TARAHUMARA TRUCKING - SITE DEVELOPMENT PLAN

TARAHUMARA TRUCKING COVER SHEET 2260 ANDES WAY AURORA, CO 80011

TARAHUMARA TRUCKING
JOB NO 954-1
CAD NO 954-1
DATE 03/30/23
SITE PLAN 2260 ANDES WAY
AURORA, CO 80011

JOB NO	954-1
CAD NO	954-1
DATE	03/30/23
TARAHUMARA TRUCKING	UTILITY PLAN
2260 ANDES WAY	AURORA, CO 80011

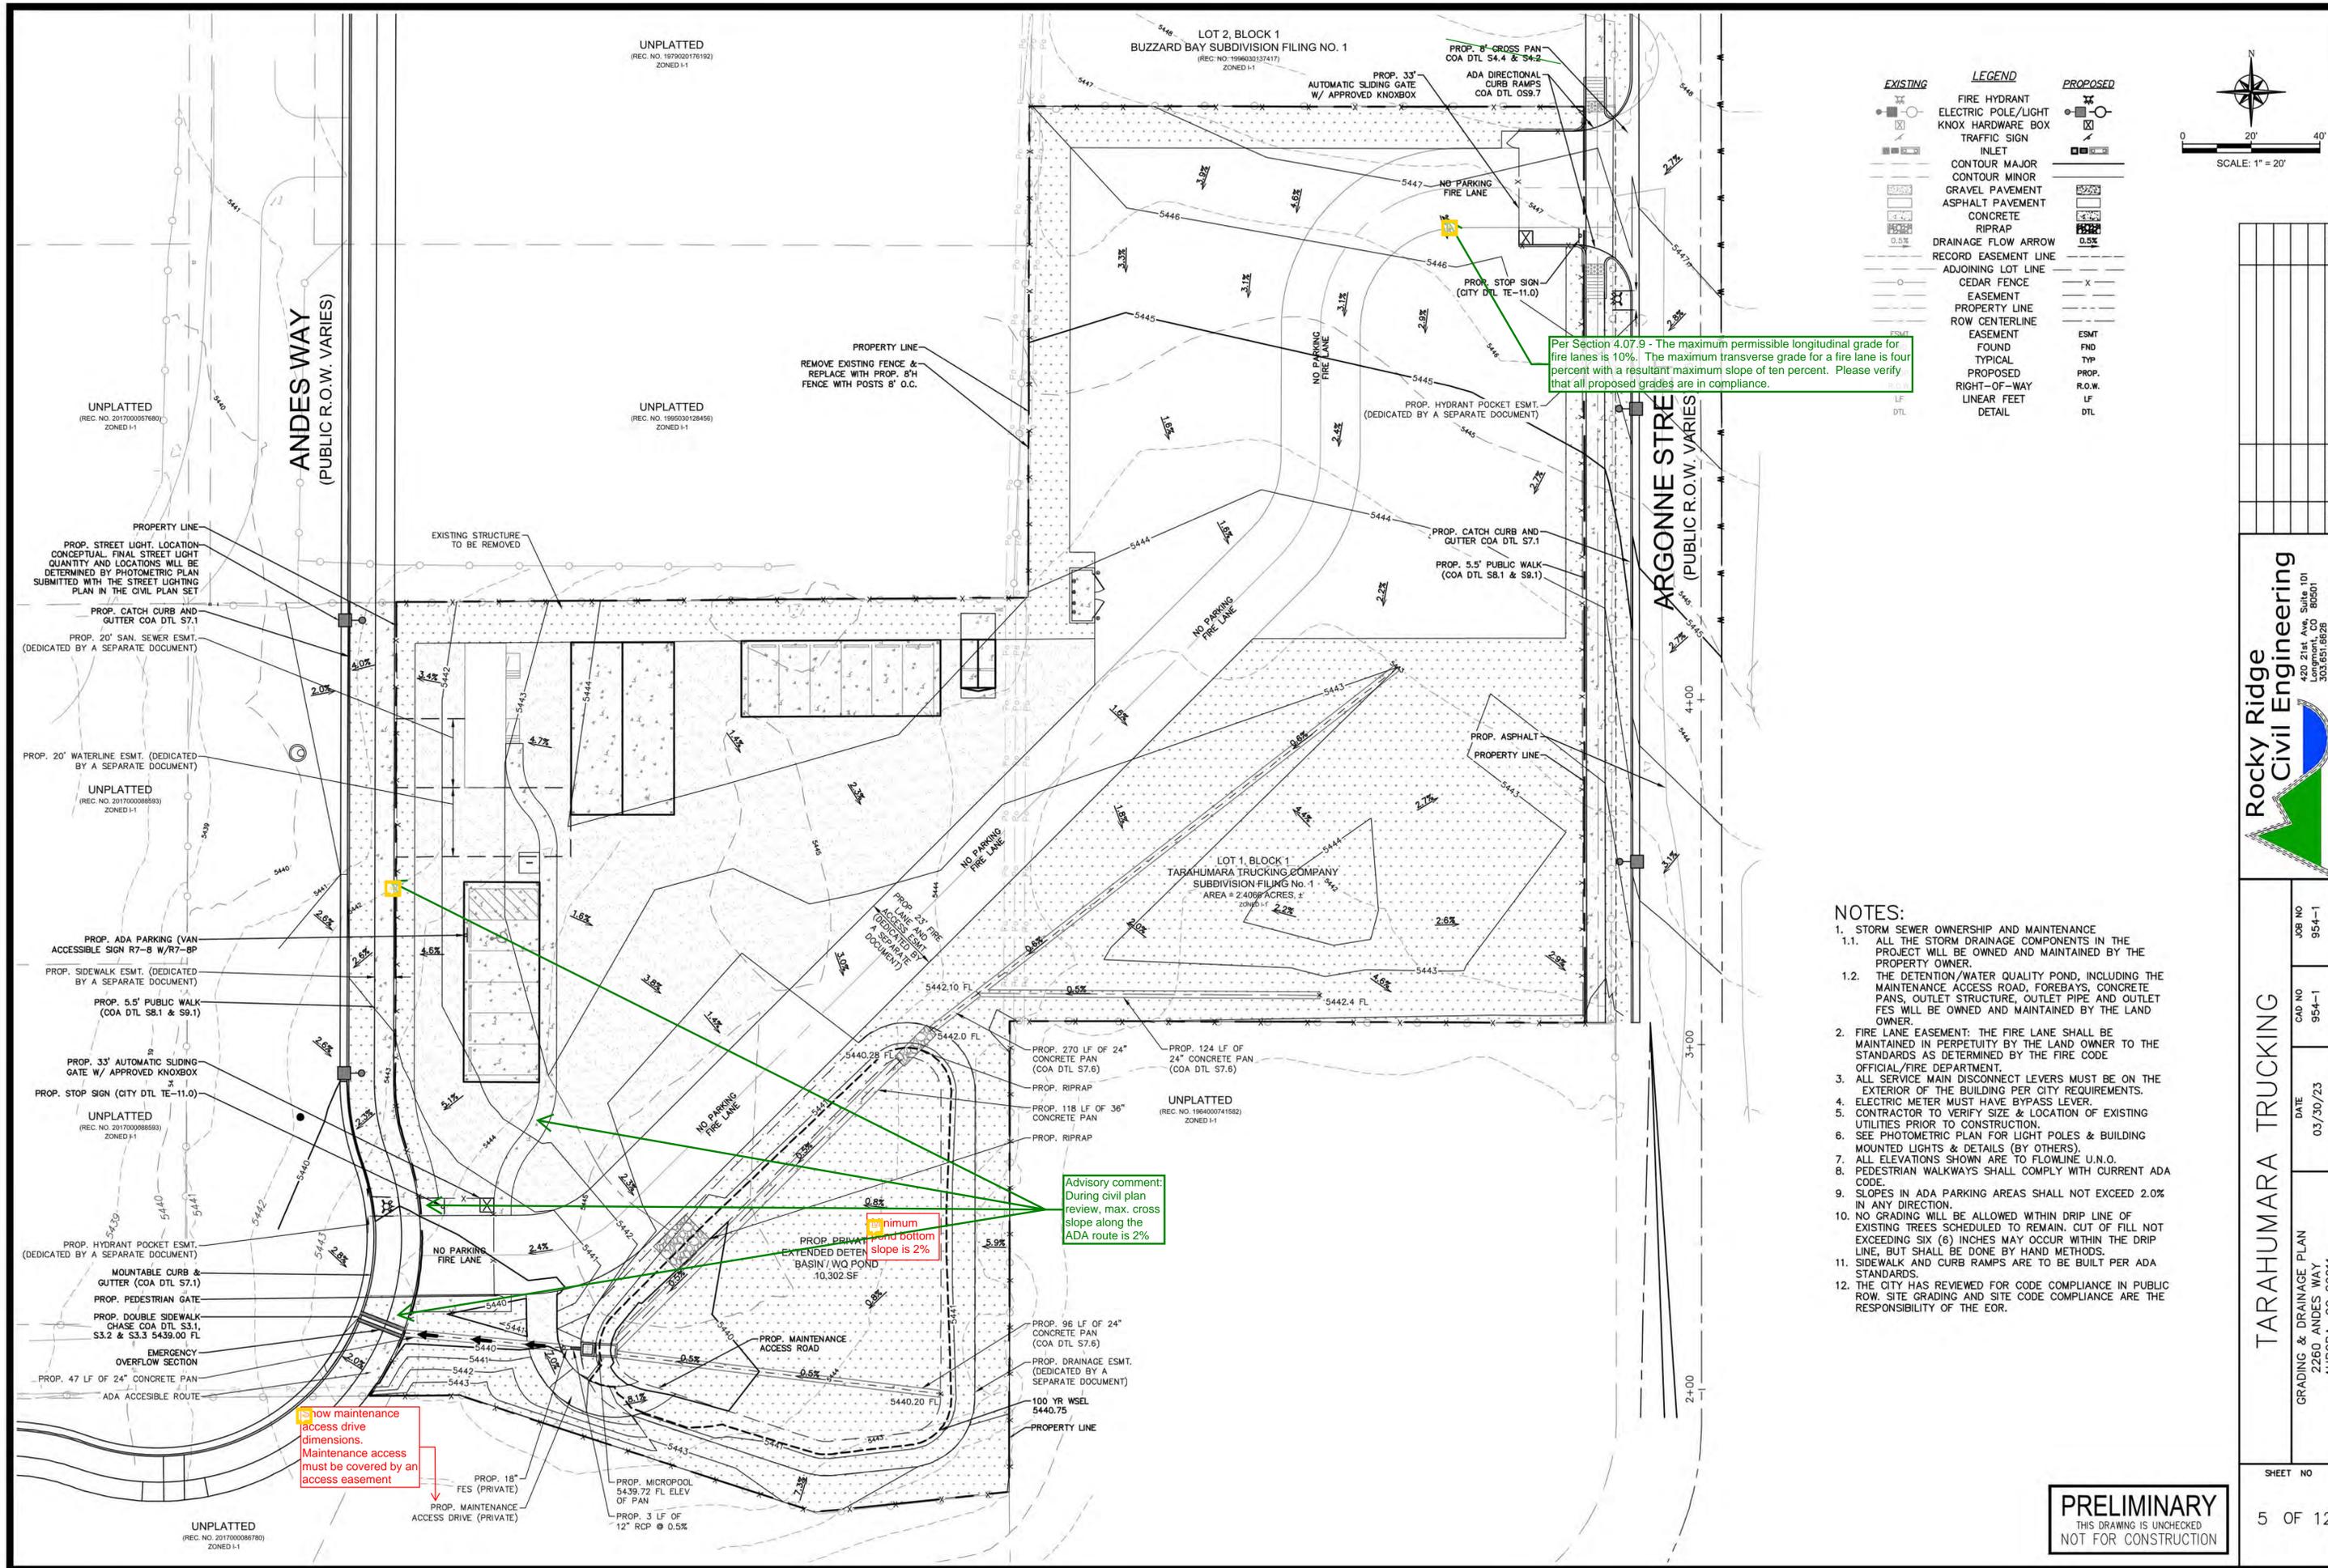
Label proposed water main

Label blow off at the end of main extension

Show connections to existing mains

Manholes are not required for connections between proposed sanitary mains and services.

Easements are not required

Label proposed manhole

Label outlet structure

Show unique overflow arrow

Show: 1) 100-yr WSEL 2) Pond side and bottom slopes

Why are two hydrants located so close to each other?

please define all abbreviations.

JOB NO	954-1
CAD NO	954-1
DATE	03/30/23
GRADING & DRAINAGE PLAN	2260 ANDES WAY AURORA, CO 80011

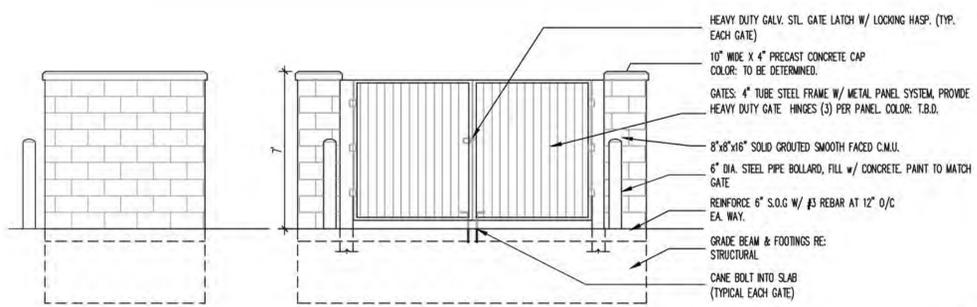
Per Section 4.07.9 - The maximum permissible longitudinal grade for fire lanes is 10%. The maximum transverse grade for a fire lane is four percent with a resultant maximum slope of ten percent. Please verify that all proposed grades are in compliance.

Advisory comment: During civil plan review, max. cross slope along the ADA route is 2%

How maintenance access drive dimensions. Maintenance access must be covered by an access easement

ARGONNE STREET & ANDES WAY SECTION
LOCAL TYPE 3 (S1.2)
(TYPICAL)
N.T.S.

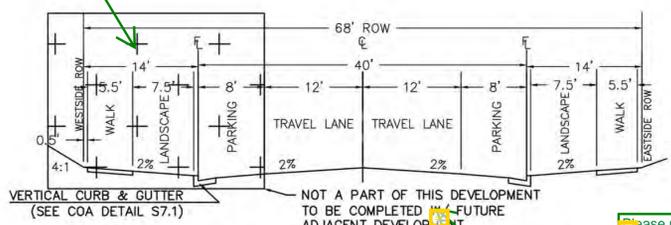
Please provide two different typical sections for Andes Way and Argonne Street (to make it clear which street is requesting a deferral)

A deferral is not guaranteed, please refer to previous notes

HANDICAPPED PARKING SIGN DETAIL
N.T.S.

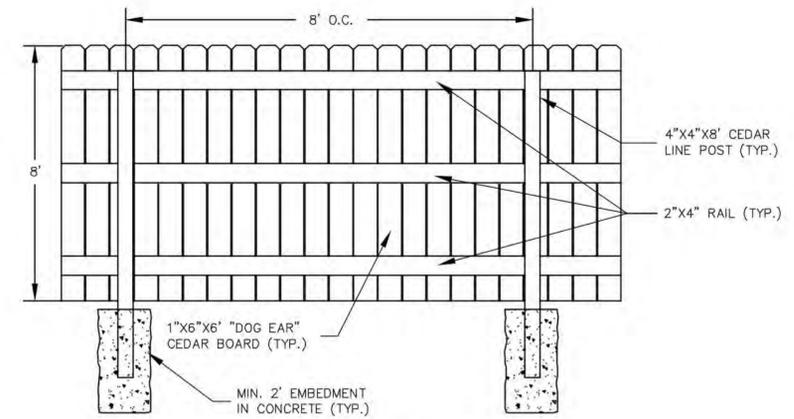
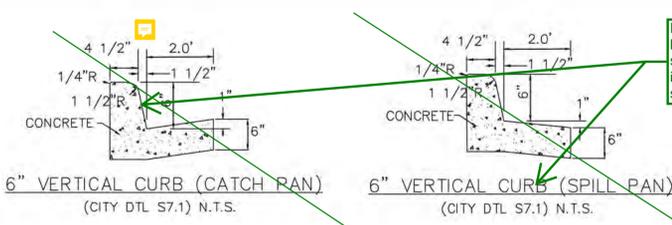
Please detail with All sign posts and sign supports shall comply with COA Standard Detail TE-11

check with Traffic to determine if the tow-away sign need to be revised to the graphic tow-away sign. Also, and the van accessible sign to the signage and stripping package.

AUTOMATIC GATE DETAIL
N.T.S.

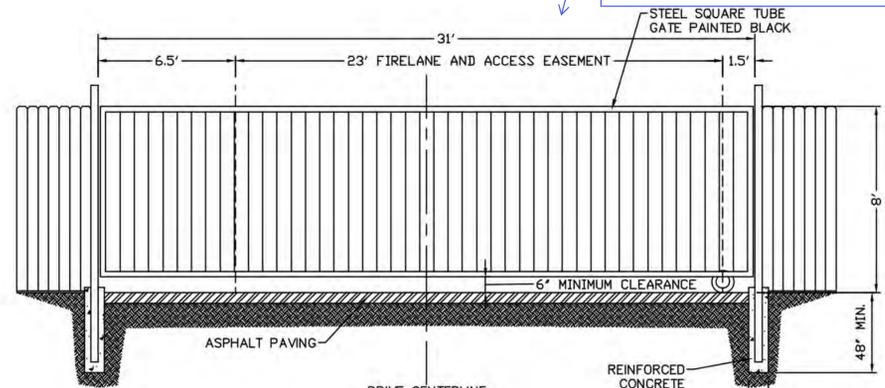
The gate label must include width, operating mechanism, Knox hardware, automatic/manual, etc., details. Example 23' Automatic Sliding Gate with approved Siren Operated System, Knox Key Switch and Manual Release.

LANDSCAPE PLAN

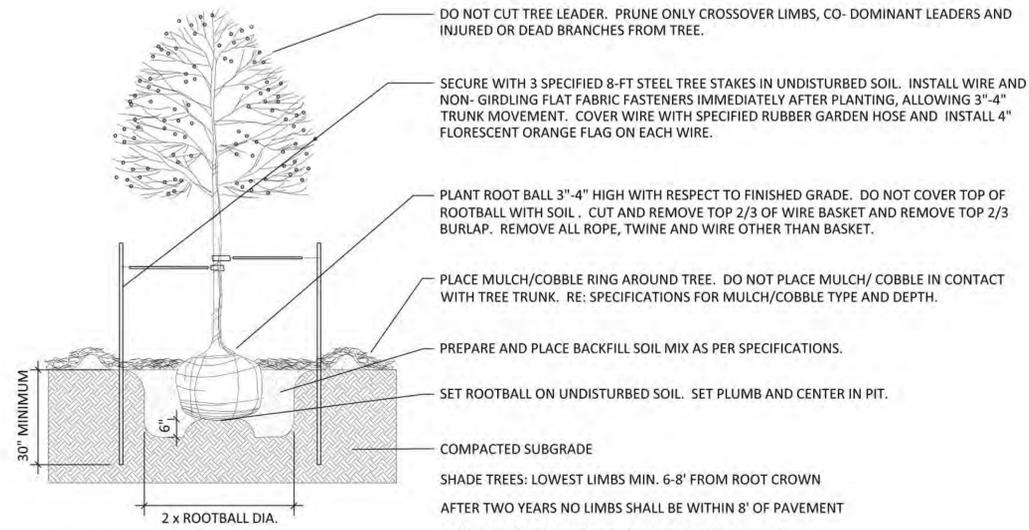
Please have the proposed seed mix add up to 100%.

Please correct the sf, as the proposed numbers do not add up on the Water Use Table.

Please add the required and proposed shrubs to the curbside landscaping. Also, please add the width of the proposed curbside landscaping both on the chart and landscape plans.

Please provide the required 20' wide landscape buffer or show how this is being reduced to 12' depending upon the landscape incentive feature chosen as specified in Table 4.7-2 Required buffer widths and allowed reductions. (Typical to all buffers) ***It appears that there is a proposed 8' tall wood fence on Sheet 4 and a detail on Sheet 6. However, it is not labeled or indicated on the landscape plans.

Please add "Not for Construction" to the plans.

TARAHUMARA TRUCKING
 PHOTOMETRICS
 2260 ANDES WAY
 AURORA, CO 80011

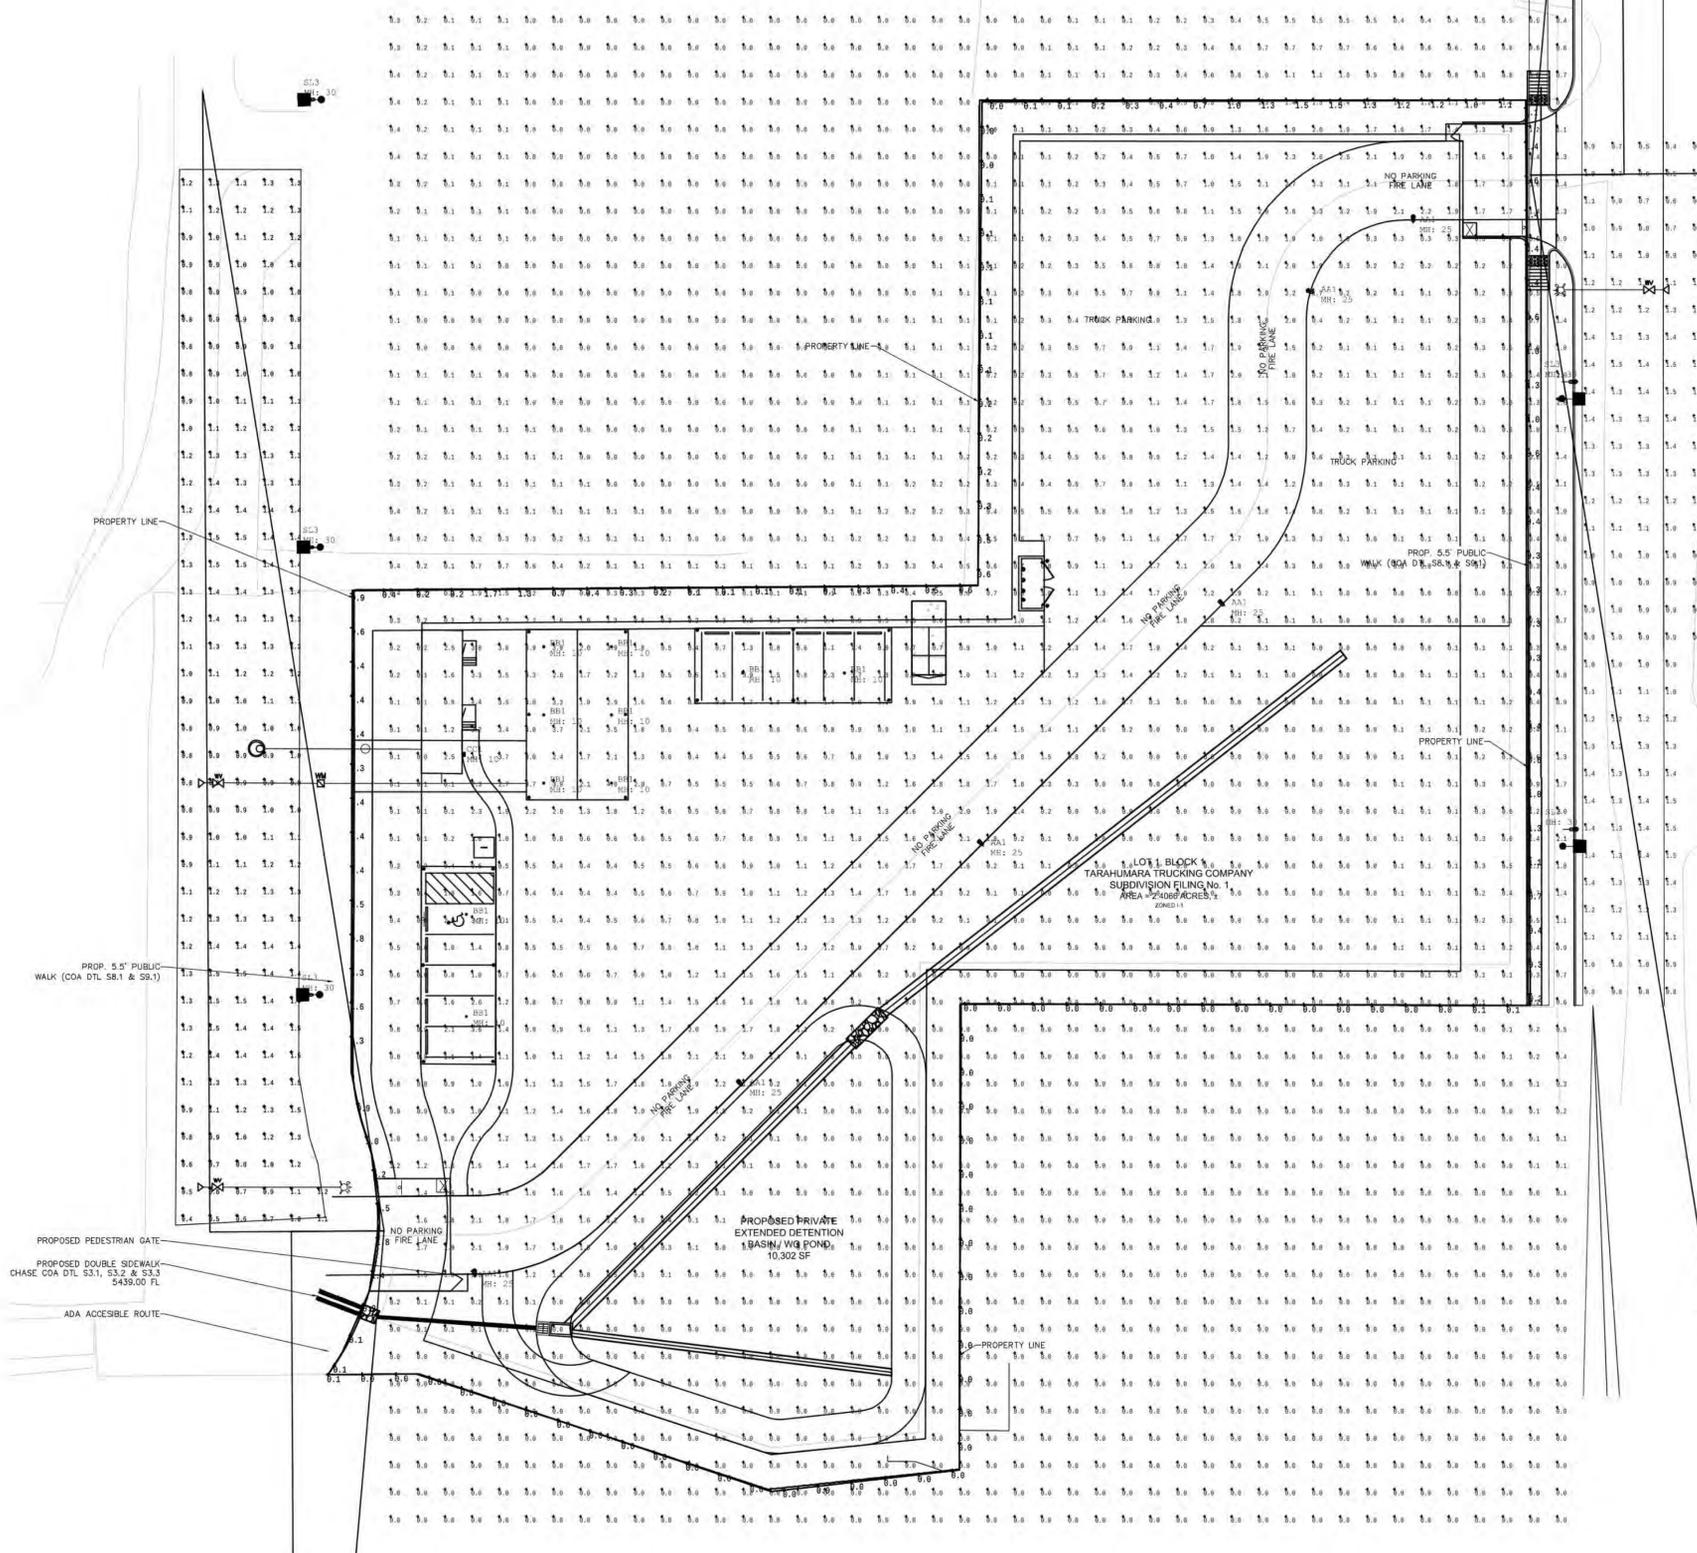
Please include all missing criteria required on site plans for lighting per section 2.12.0.1

Show the accessible route to the accessible parking by heavy dashed line. Verify minimum 1 foot-candle of illumination along its entire length.

Add the following note to the Photometric Site Plan: ILLUMINATION WITHIN THE SITE MUST COMPLY WITH THE 2015 INTERNATIONAL BUILDING CODE REQUIREMENT FROM SECTION 1006 - MEANS OF EGRESS ILLUMINATION. SECTION 1006. ILLUMINATION REQUIRED: THE MEANS OF EGRESS, INCLUDING THE EXIT DISCHARGE, SHALL BE ILLUMINATED AT ALL TIMES THE BUILDING IS OCCUPIED. SECTION 1006.2 ILLUMINATION LEVEL. THE MEANS OF EGRESS ILLUMINATION LEVEL SHALL NOT BE LESS THAN 1 FOOT-CANDLE (11 LUX) AT THE FLOOR LEVEL, AND CONTINUING TO THE "PUBLIC WAY".

Please add the following note: "Proposed street light locations are conceptual. Final locations will be determined with photometric analysis submitted with the street lighting plans in the civil plan submittal."

-Add light pole detail, including height

Disy comment: Public street lights will be required to be submitted with a photometric analysis during the civil plan review process and lighting submittal must match one of the current pre-approved public street lighting equipment list. (ALL)
